**MITIGATED DETERMINATION OF NONSIGNIFICANCE  
STATE ENVIRONMENTAL POLICY ACT**

**BETHEL SCHOOL DISTRICT NO. 403  
NEW BETHEL HIGH SCHOOL PROJECT**

Date of Issue of MDNS: September 22, 2023

## Groundwater Elevation October 2020

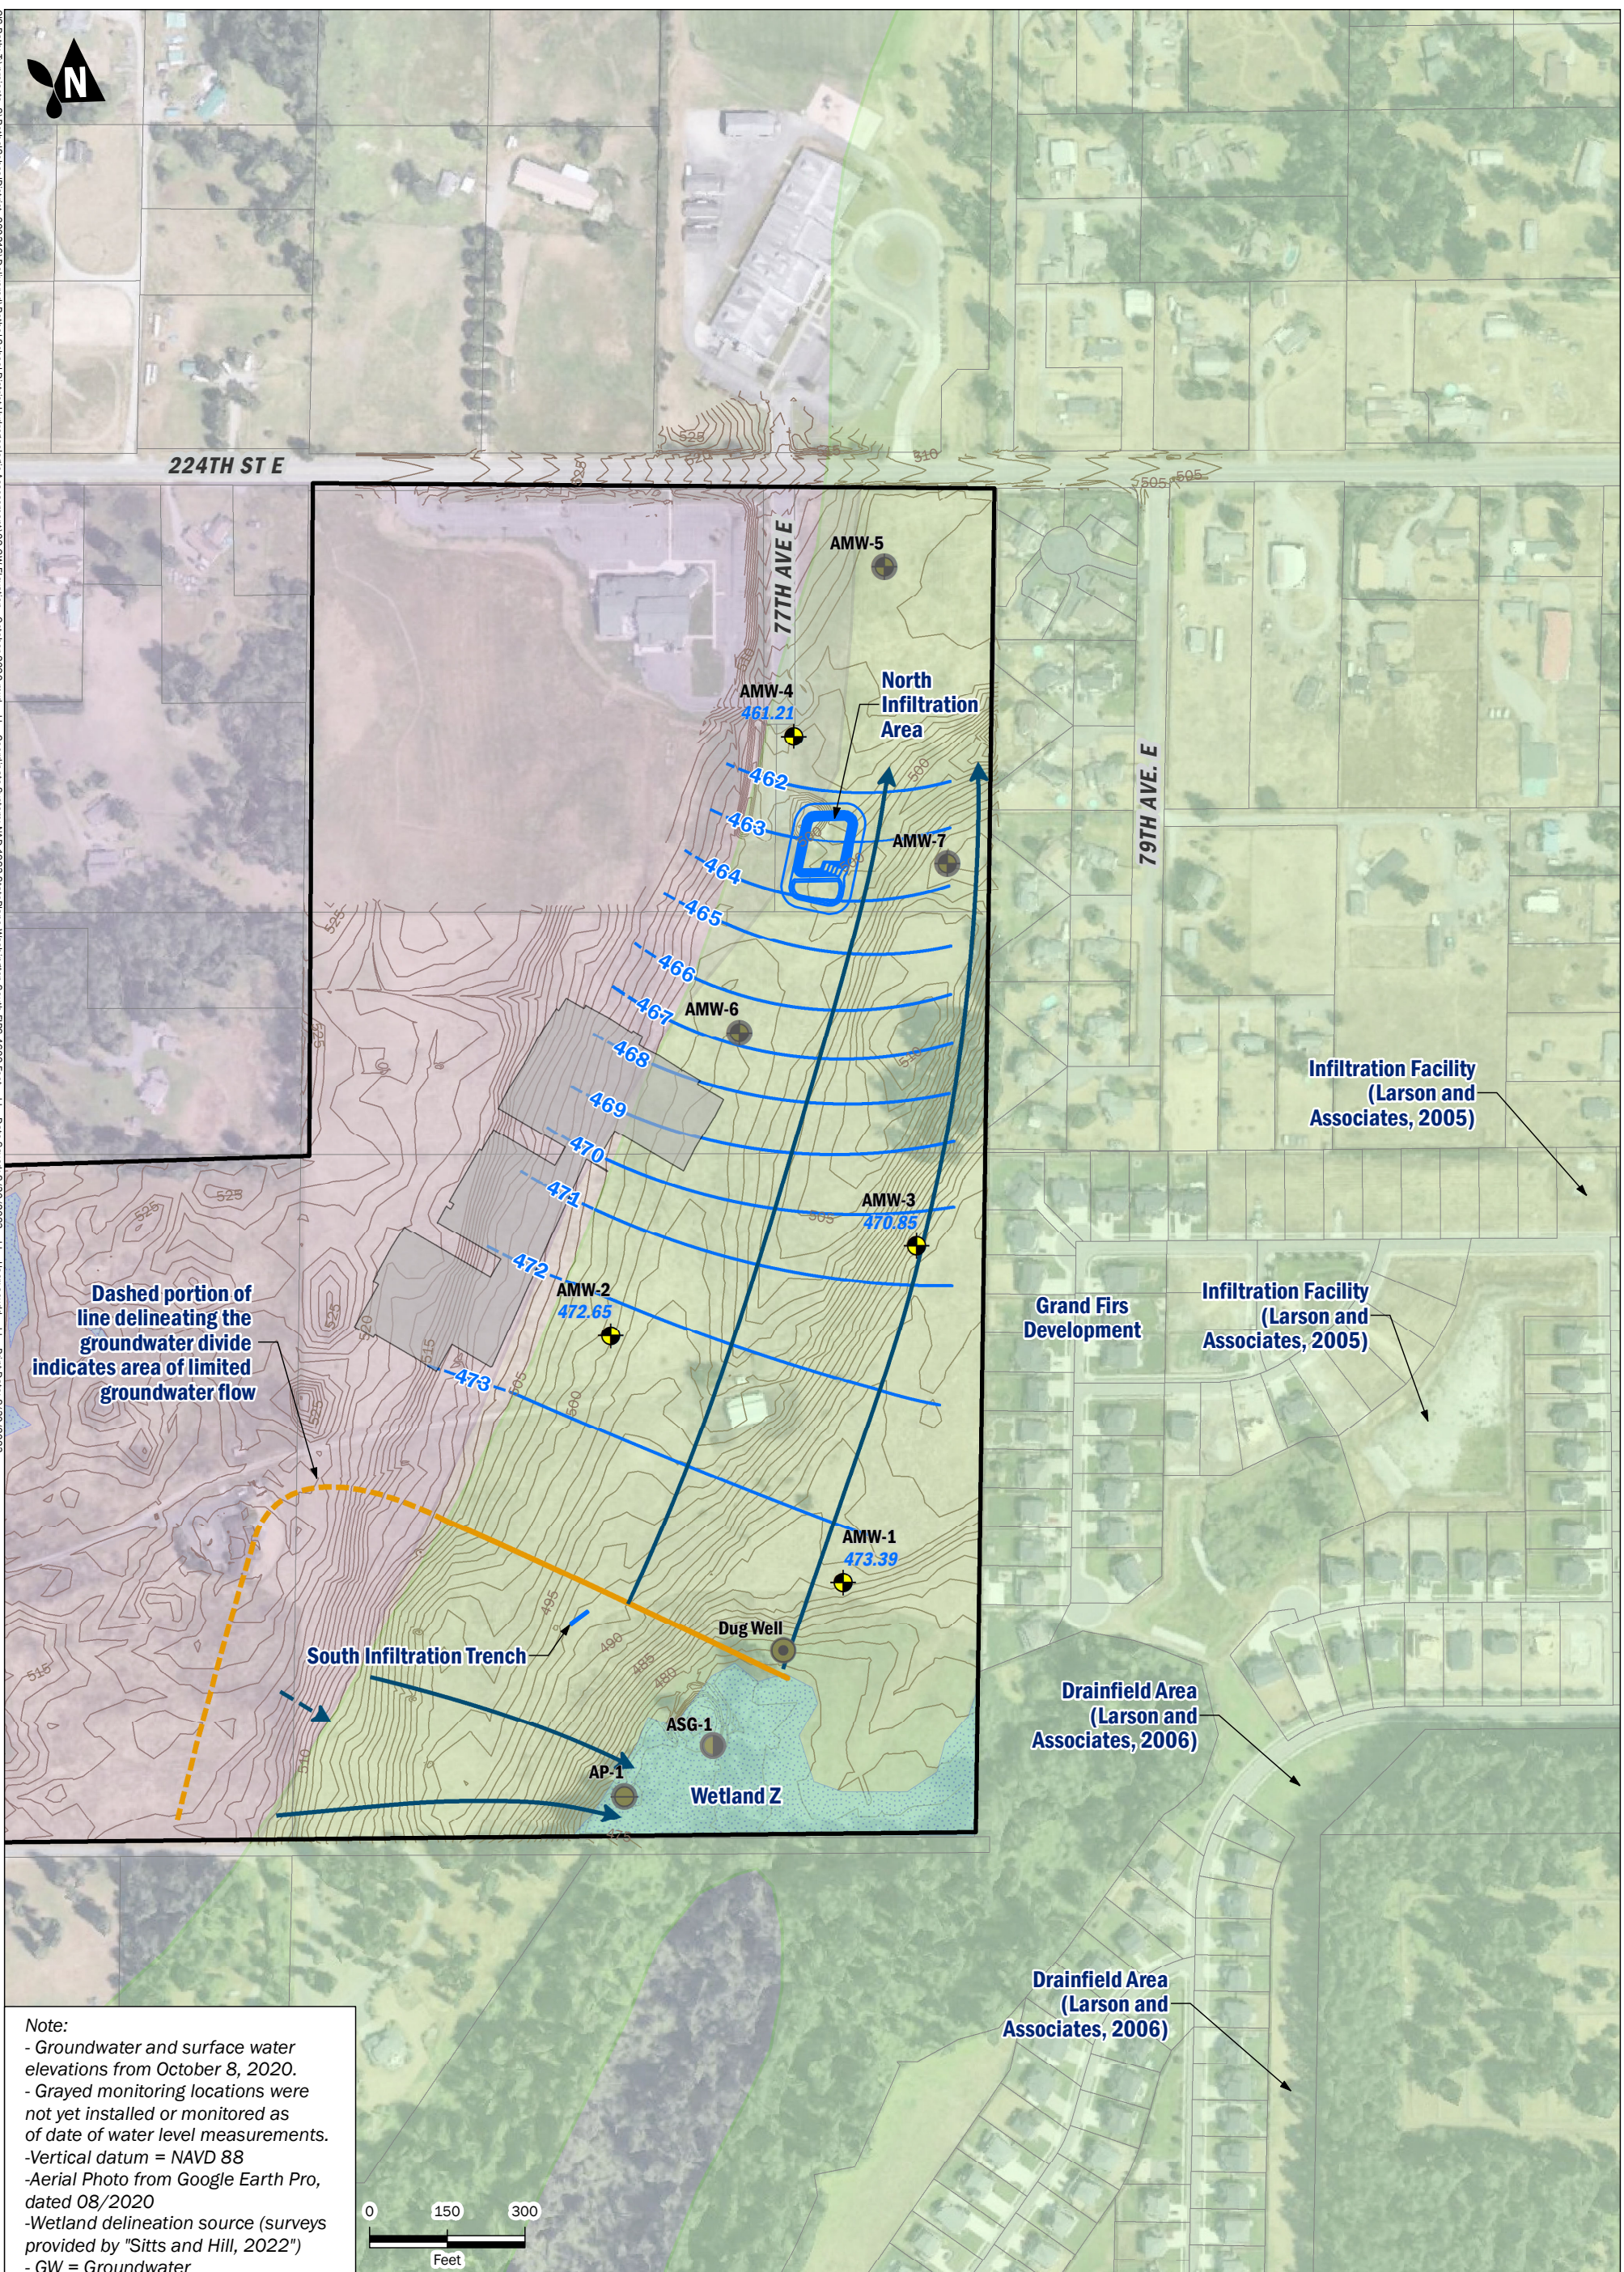
Concerns that Site stormwater management will exacerbate existing flooding at the Grand Firs Development can be evaluated from the groundwater contour maps prepared using groundwater level data collected during the Site investigation (Figures 5 through 8 in the Aspect [2023] report), which are included with this memo as Figures 1 through 4 with the addition of flowlines to show the approximate directions of groundwater flow at the Site relative to the Grand Firs Development. As discussed in Section 3.1.4.1 of the Aspect (2023) report, groundwater flows from the Grand Firs Development (where groundwater levels become elevated) toward the central portion of the Site during the wet season. The photo documentation of flooding within the Grand Firs Development provided by Halmo (2023) supports this finding, as it presents evidence of groundwater levels exceeding those measured at the Site.
